MERRITT COLLEGE
SECONDARY POWER SUBSTATION C REPLACEMENT

ADDENDA

BID NO. 23-24/02

ADDENDUM No. 1

DRAWN BY	EM
CHECKED BY	THOMAS JUN
JOB NO.	2022-0586
DATE	11/23/2022
SHEET NUMBER	E3.1

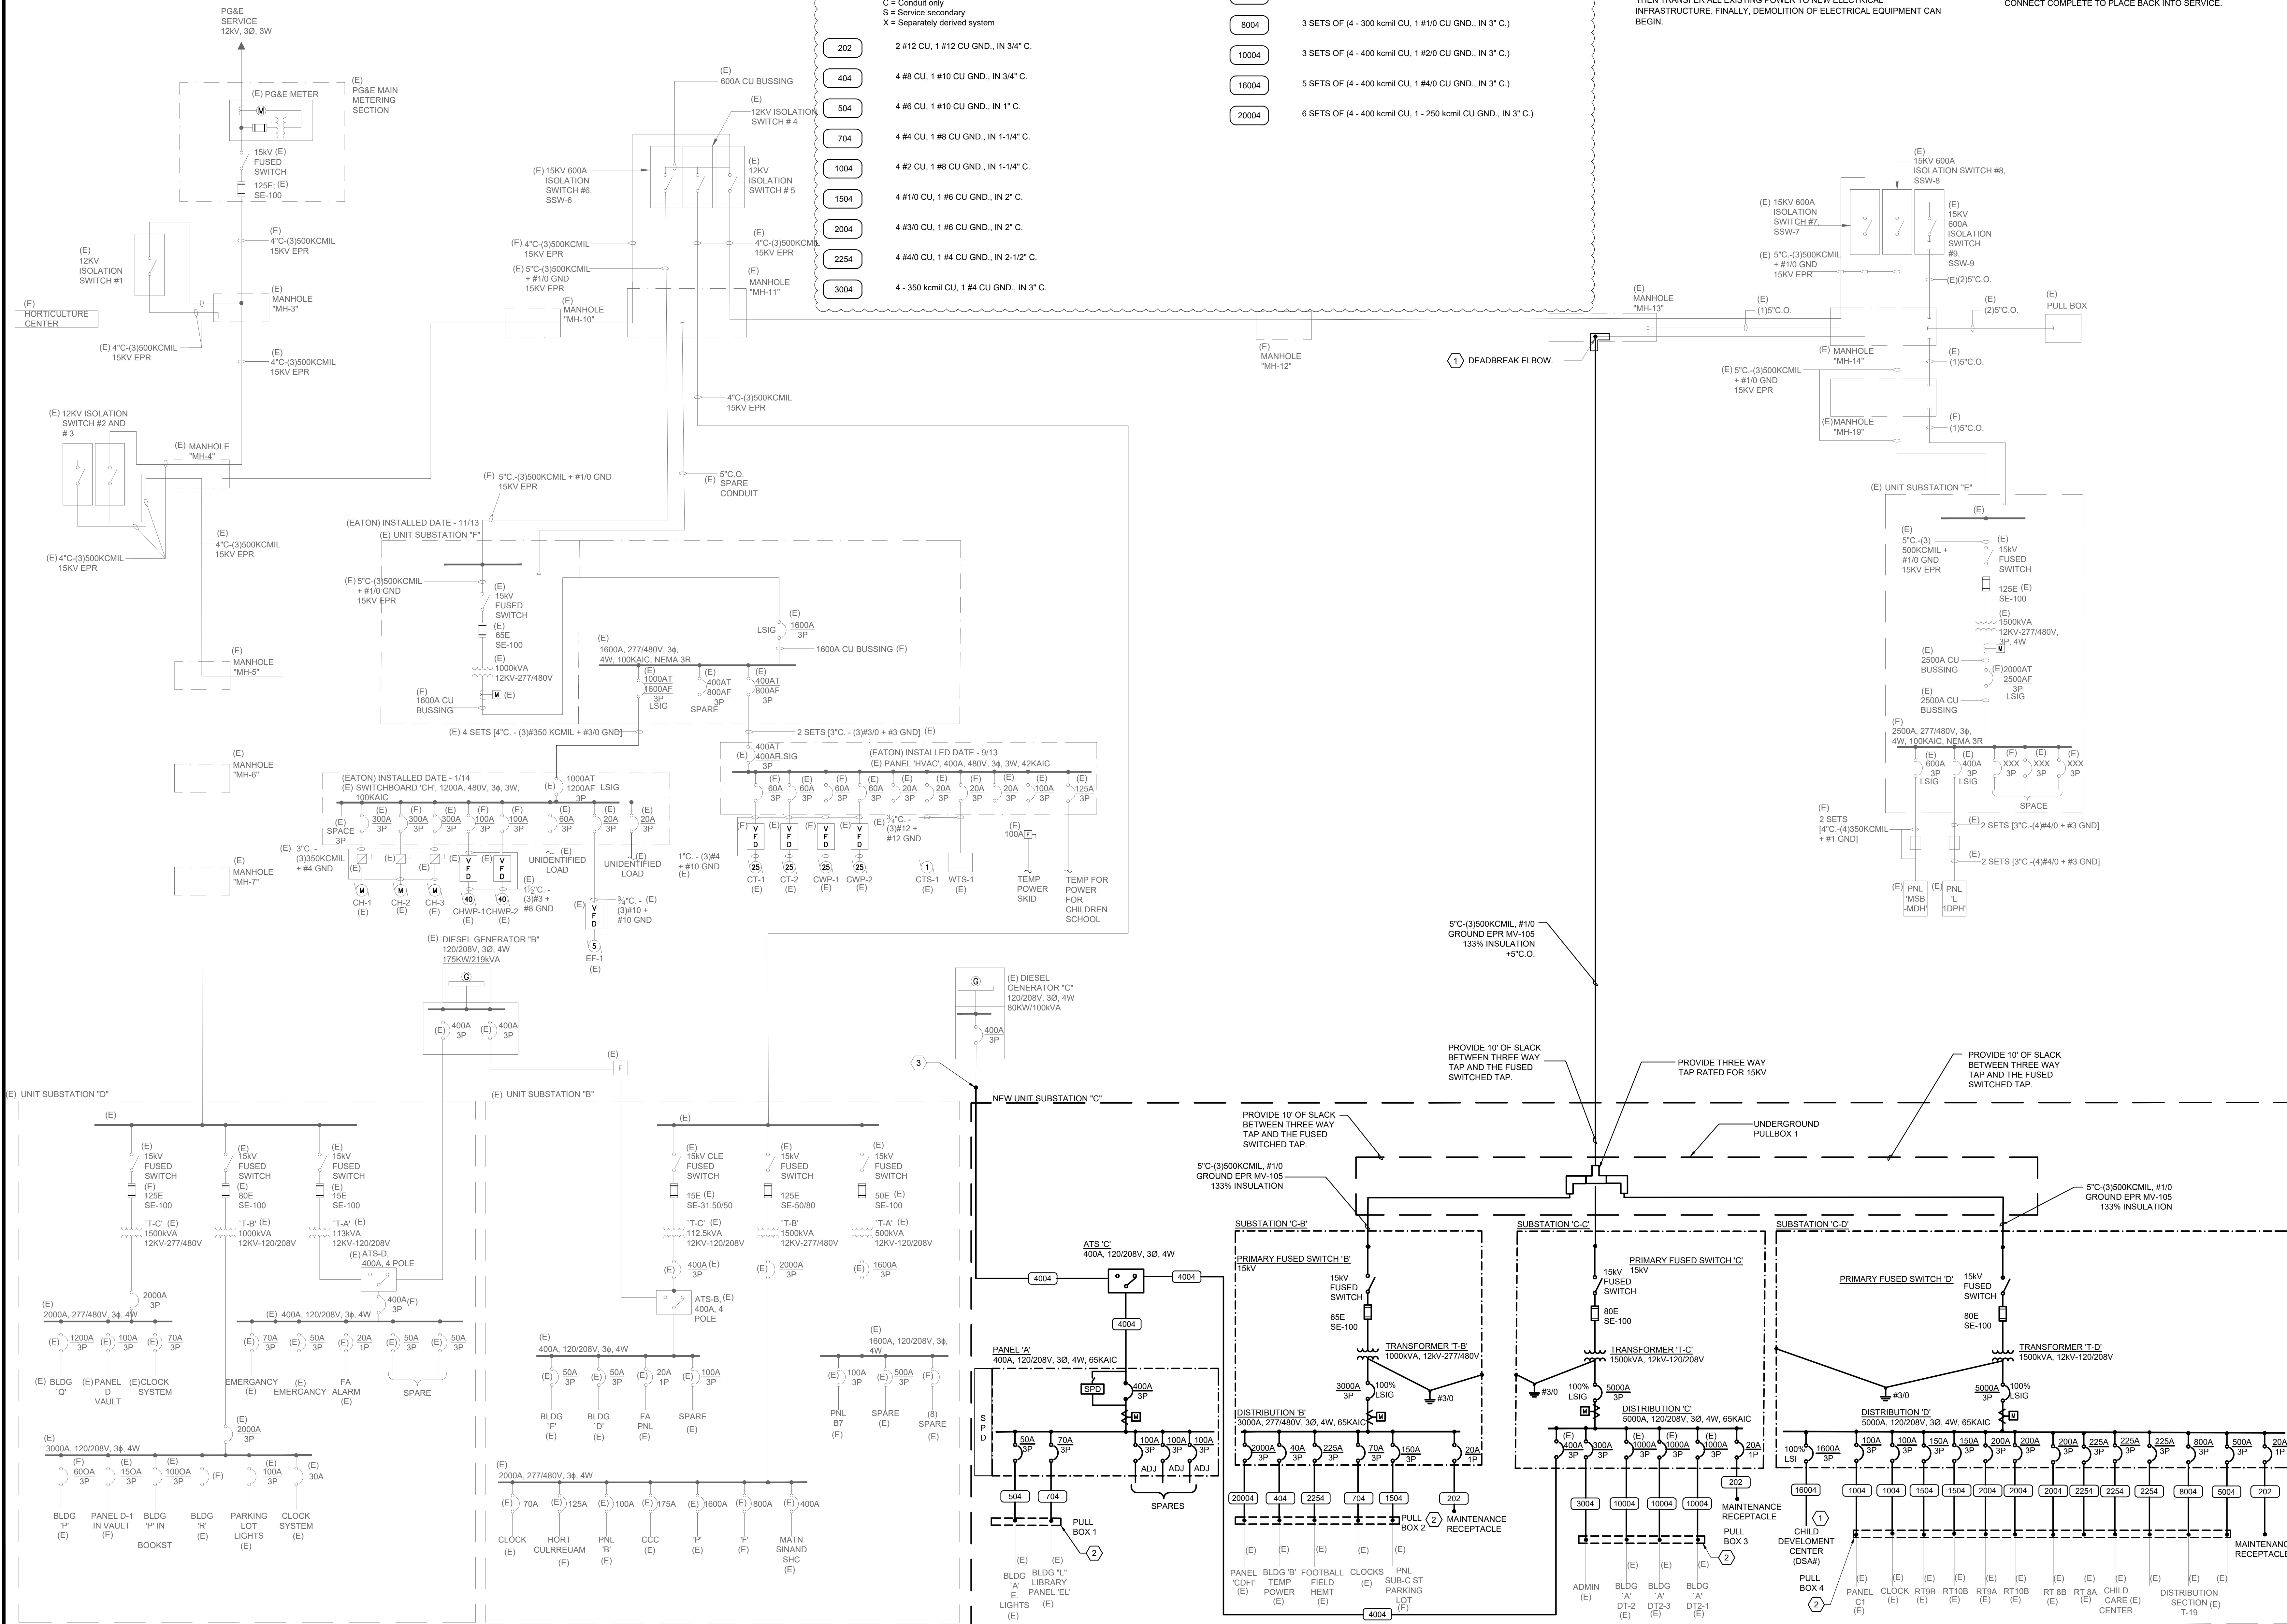
1.1 Sheet E3.1, dated 5/25/2023

8. **Q.** Please clarify the sequencing expected for the 480v feeder cutovers. The sequence described on Drawing E3.1 - General Note 2 - seems to conflict with Drawing Sheet Note 2. How are we supposed to splice the 480V feeders in new Pullboxes 1, 2, 3, & 4 when these boxes are not going to be installed until after the old substation is removed? If the pullboxes will be installed after the demolition of the existing substations, then there will be considerable downtime involved. Please clarify.

9. **Q.** Drawing E3.1 - Feeder Schedule only lists 4004. There are several other feeder sizes called out but the feeder information is not provided. Please provide information for other feeders sizes (20004, 404, 2254, etc.).

1.1.1 Replace with revised Sheet E3.1, dated 8/11/2023

A. Existing substations are on top of openings that were used to feed the existing 480V load, these will eventually turn into pullboxes once the existing substation are gone.

- A. See attached revised Sheet E3.1
10. **Q.** Civil drawings do not appear to call out concrete encasement backfill for the new 5" conduits called out on the electrical site plan. Please clarify is encasement will be required for new installed conduits.
